INSTRUCTION SHEET

To update your copy of the Marble Hill Nuclear Generating Station - Units 1 and 2 Environmental Report - Operating License Stage, please remove the indicated pages and replace them with the attached Supplement 1 pages.

QUESTIONS AND RESPONSES

This section contains U.S. Nuclear Regulatory Commission requests for additional information based on Darrell G. Eisenhut's letter of February 23, 1983, followed by the response to each question. In some cases the response includes a reference to the applicable updated sections of the text of the ER-OL.

FIGURE Q240.1-1

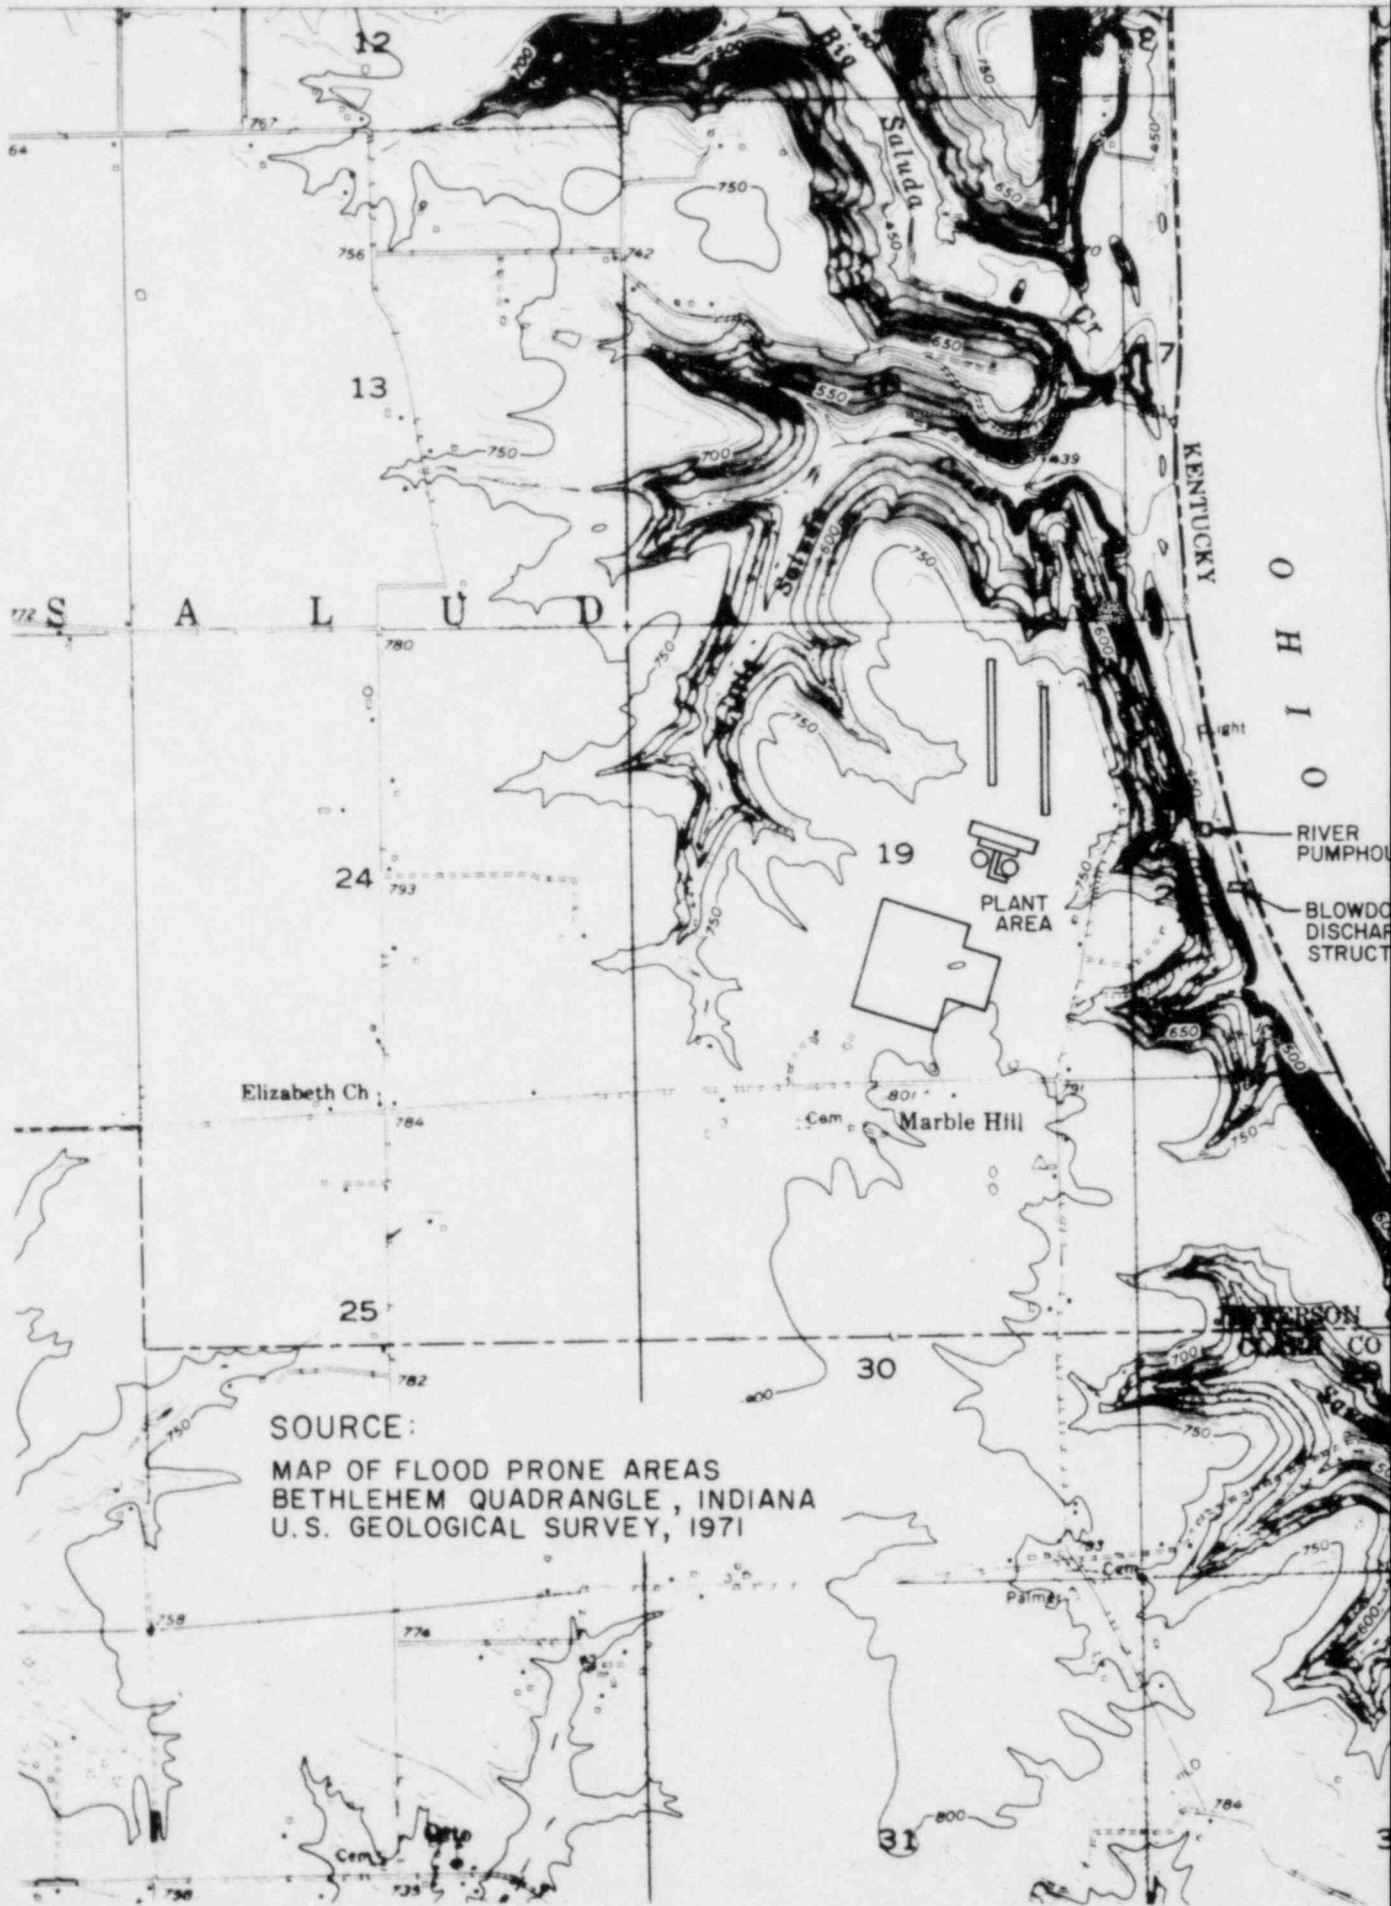
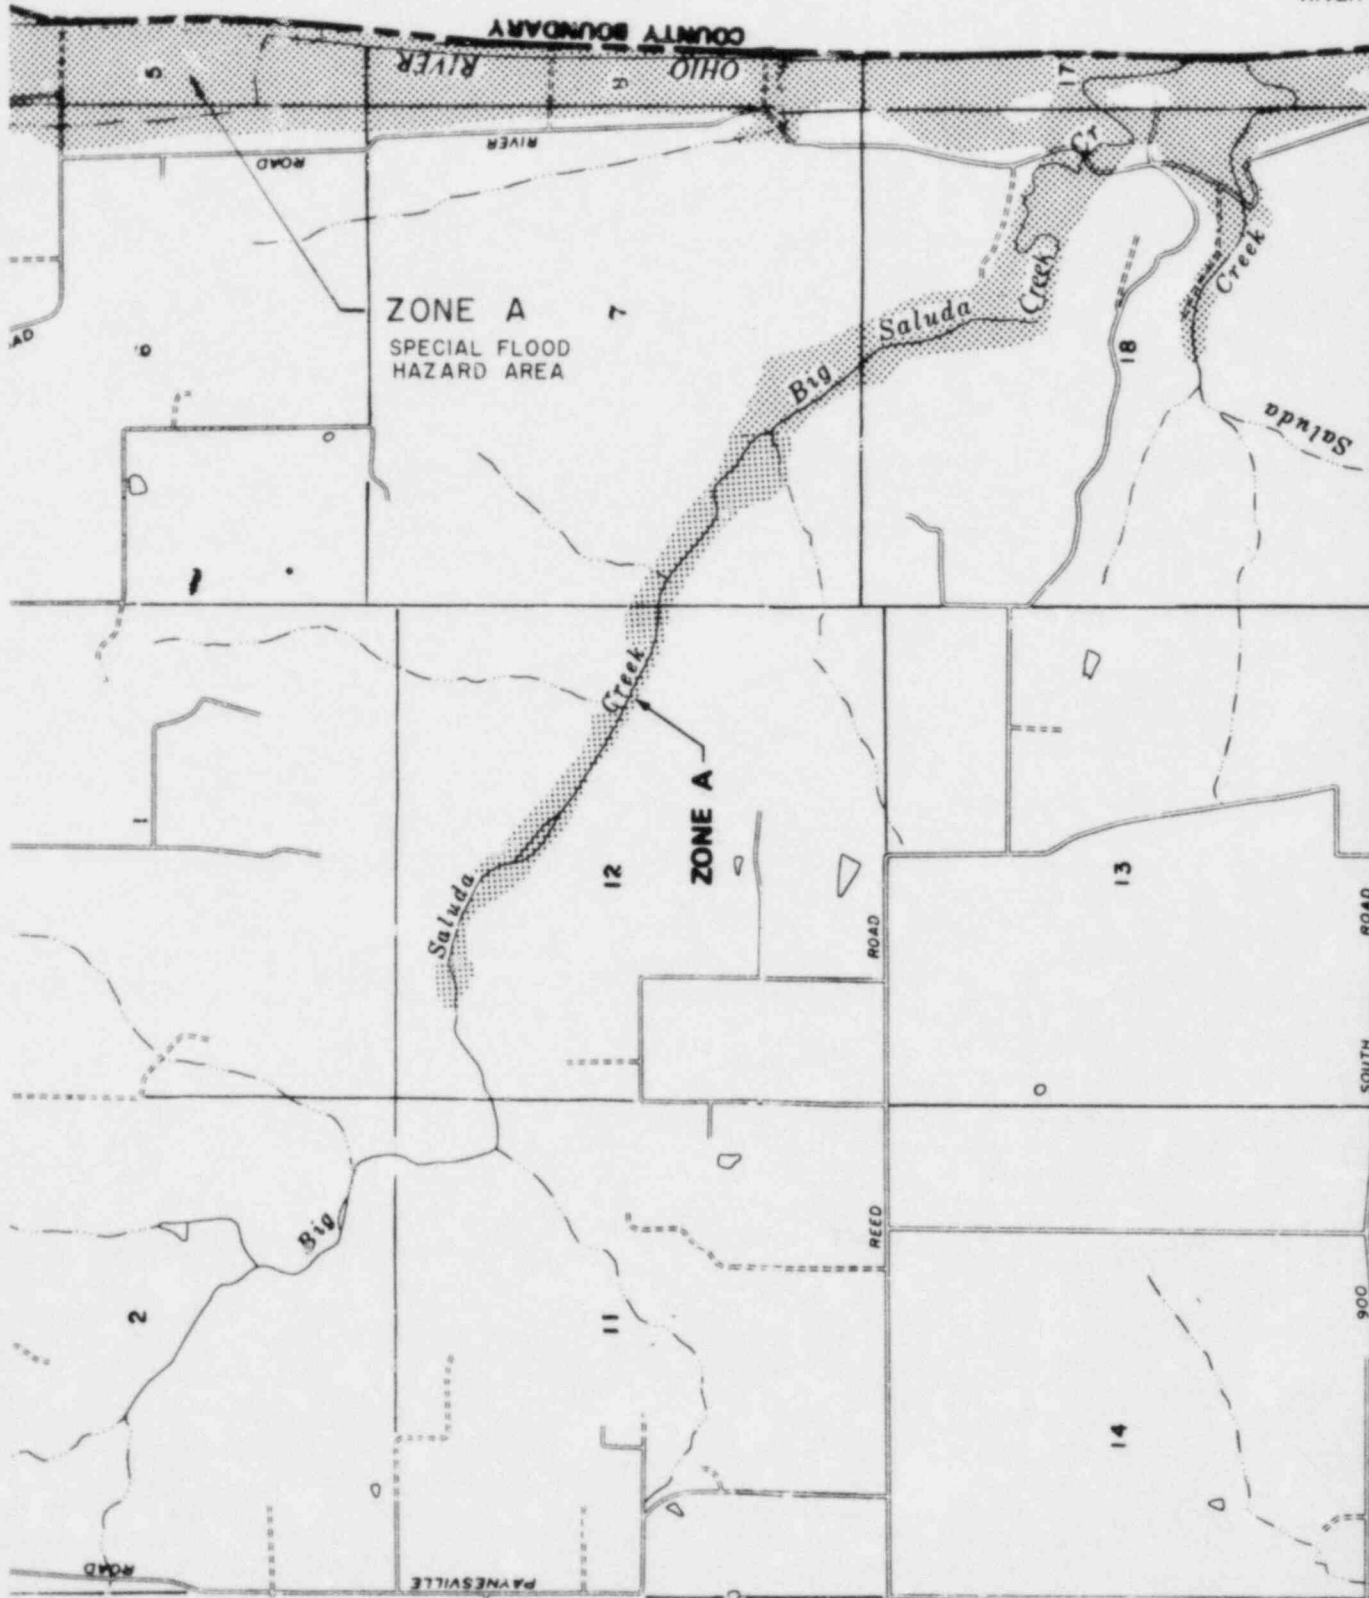
- a. Provide descriptions of the floodplains of all water bodies, including intermittent water courses, within or adjacent to the site. On a suitable scale map provide delineations of those areas that will be flooded during the one-percent chance flood in the absence of plant effects (i.e., pre-construction floodplain).

- b. Provide details of the methods used to determine the floodplains in response to a. above. Include your assumptions of and bases for the pertinent parameters used in the computation of the one-percent flood flow and water elevation. If studies approved by Flood Insurance Administration (FIA), Housing and Urban Development (HUD) or the Corps of Engineers are available for the site or adjoining area, the details of analyses need not be supplied. You can instead provide the reports from which you obtained the floodplain information.

- c. Identify, locate on a map, and describe all structures and topographic alterations in the floodplains.
- d. Discuss the hydrologic effects of all items identified in c. above. Discuss the potential for altered flood flows and levels, both upstream and downstream. Include the potential effect of debris accumulating on the plant structures. Additionally, discuss the effects of debris generated from the site on downstream facilities.

- e. Provide the details of your analysis used in response to d. above. The level of detail is similar to that identified in item b. above.
- f. The floodplain mapping should be of suitable quality for use in the Environmental Statement.

The flood prone area due to the 1% probability flood in the Ohio River in the vicinity of the Marble Hill site is shown in Figure Q240.1-1. This figure was reproduced from the United States Geological Survey flood prone area map for Bethlehem Quadrangle, Indiana-Kentucky (U.S. Geological Survey 1971). Figure Q240.1-2 shows the flood hazard area of the Ohio River as delineated by the Federal Insurance Administration (U.S. Department of Housing and Urban Development 1978, 1980). Figures Q240.1-1 and Q240.1-2 show the flood prone areas prior to the construction of Marble Hill 1&2.

The main plant structures, river pumphouse, and blowdown discharge structure constructed for Marble Hill 1&2 are also shown in Figures Q240.1-1 and Q240.1-2. It is evident from these figures that the main plant area, including most of the plant-related facilities, does not alter the floodplain of the Ohio River or its tributaries, and hence does not affect the flood prone areas.

The river pumphouse and the blowdown discharge structure are the only plant-related facilities that might have a detectable affect on flood levels. They are located in the floodplain of the Ohio River, near River Mile 570, as shown in Figures Q240.1-1 and Q240.1-2. The river pumphouse and the approach road to the pumphouse occupy a small portion of the Ohio River floodplain as shown in Figure Q240.1-3. The intake to the pumphouse is by submerged intake screens connected to the pumphouse by pipelines buried under the existing grade of the floodplain. The blowdown into the river is by submerged discharge through a buried pipeline that extends into the river. Therefore, the blowdown discharge structure and intake pipelines do not affect the flood prone area.

The 100-year flood elevation in the Ohio River at the location of Marble Hill 1&2 was computed by backwater analysis, starting from a section at River Mile 604, upstream of McAlpine Dam near Louisville, Kentucky. The river cross sections were obtained from the U.S. Army Corps of Engineers, Louisville District. The 100-year flood flow in the Ohio River at McAlpine Dam is 812,000 cfs (Federal Emergency Management Agency 1980), and this flow was used for the river reach from Louisville to the Marble Hill river pumphouse. The 100-year flood elevation in the river near the river pumphouse was computed to be 459.6 feet above Mean Sea Level (MSL), prior to the construction of the river pumphouse. Backwater computations with the river pumphouse in place also gave a flood level of 459.6 feet MSL, demonstrating that there was no significant effect of the construction of the river pumphouse on the 100-year flood level in the river. Also, as may be seen from Figure Q240.1-3, at the 100-year flood elevation of 459.6 feet MSL, the cross-sectional area of the river prior to

construction of the river pumphouse is 165,351 ft², and the area of encroachment due to the river pumphouse is 1,829 ft², which is only 1.1% of the original area. Hence, it is concluded that the construction of Marble Hill 1&2 and related facilities has no significant effect on flood flows or flood levels in the Ohio River or any other stream, upstream or downstream of the Marble Hill site.

No debris is expected to be generated at the Marble Hill site. Debris accumulation on the plant structures is not expected; hence, there is no potential effect on downstream flood prone areas.

FIGURE Q290.7-1

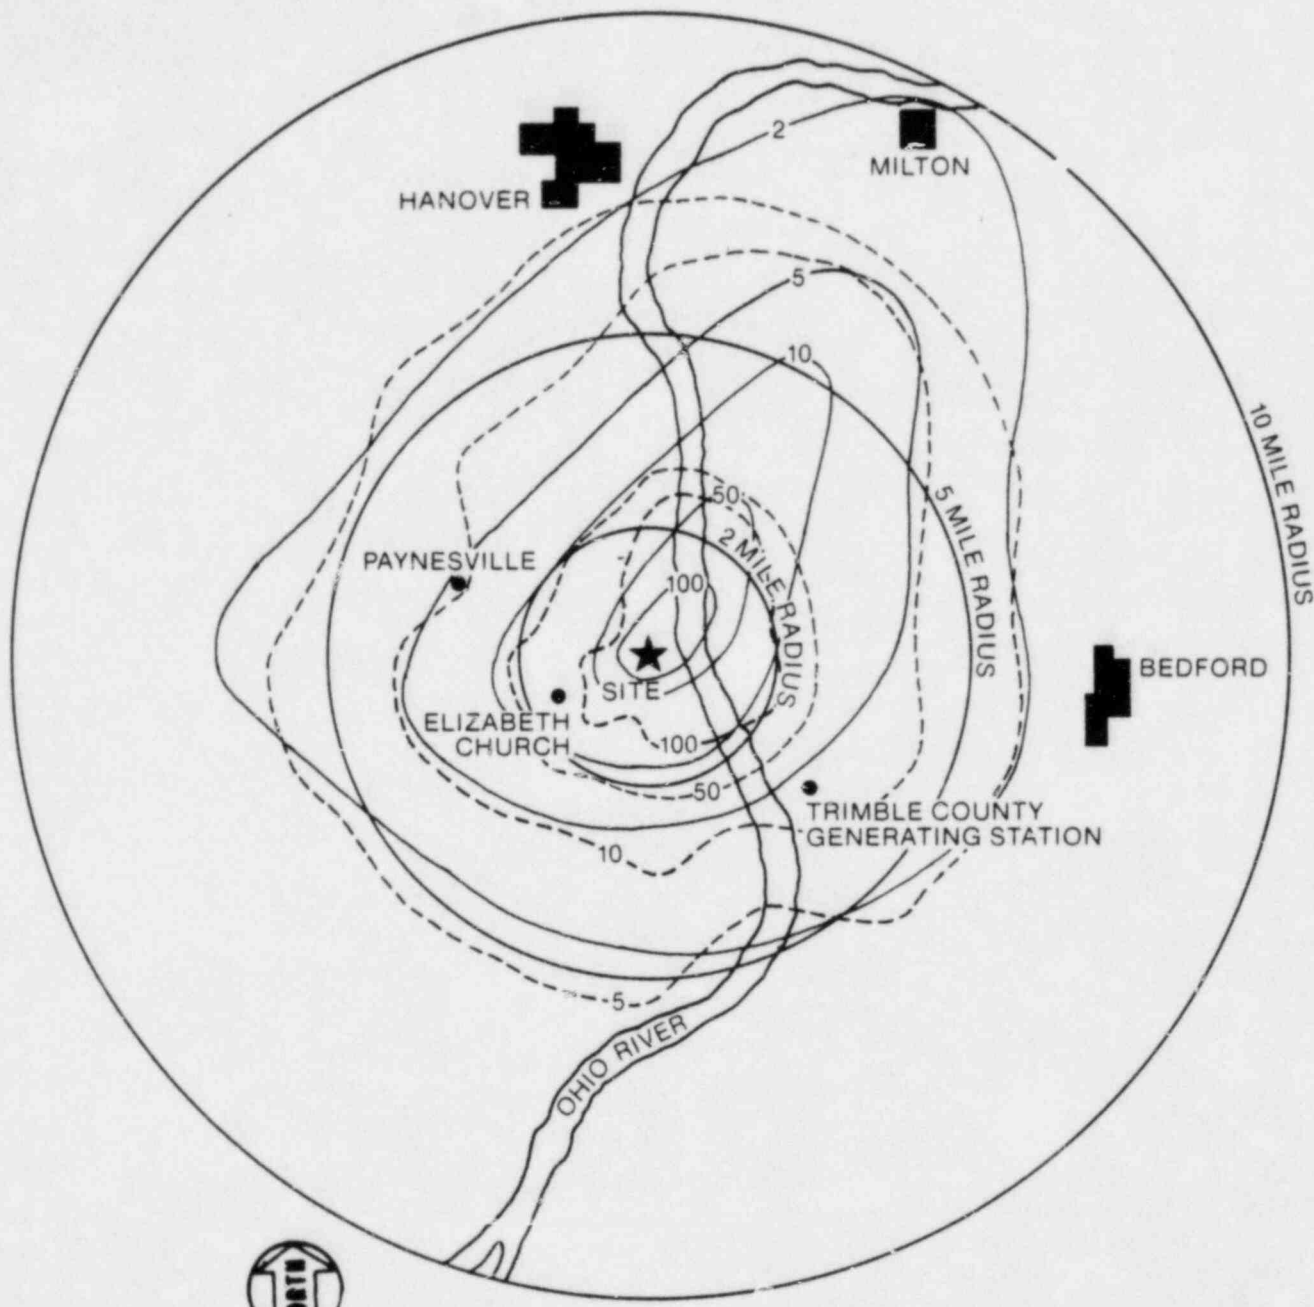
Why are the annual average drift deposition values shown in ER-OL Figure 5.1-2 higher than maximum values presented in the applicant's presentation in the FES-CP, page 5-8, given a reduction in drift rate from <0.02% of the flow to 0.008% of flow?

The drift deposition values cited in the FES-CP were extracted from the applicant's drift deposition analysis presented in Subsection 5.1.7.3.1 of the Marble Hill Environmental Report - Construction Permit Stage (ER-CP). The ER-CP and FES-CP both contain deposition values in English units (lb/acre-month). The FES-CP also contains the equivalent values in metric units (kg/hectare-month). A comparison of the metric values and English values on page 5-8 of the FES-CP indicates that the metric values should actually be approximately 6 times higher in order to correctly correspond to the English values. If the deposition values in lb/acre-month from the FES-CP are converted to kg/hectare-year and compared with the values shown in ER-OL Figure 5.1-2, the FES-CP values are found to be higher than the ER-OL values by a factor consistent with the change in the drift rate. This comparison is shown in Figure Q290.7-1. The change in the deposition is not uniform because different periods of meteorological data were used in the FES-CP and ER-OL analyses.

In responding to this question, it was discovered that the drift deposition analysis presented in the ER-OL was based on a total dissolved solids (TDS) concentration in the circulating water of 1500 mg/l. Although this concentration was the correct value at the Construction Permit stage, the TDS concentration in the circulating water is now expected to average 1635 mg/l (see ER-OL Tables 3.6-2 and 5.3-1). For consistency and conservatism, the drift deposition analysis is being revised using the higher TDS concentration. The revised values will be provided to the U.S. Nuclear Regulatory Commission by June 30, 1983. It is expected that the revised values will still be generally lower than those presented at the Construction Permit stage and will entail no significant change in environmental impacts from those currently presented in the ER-OL.
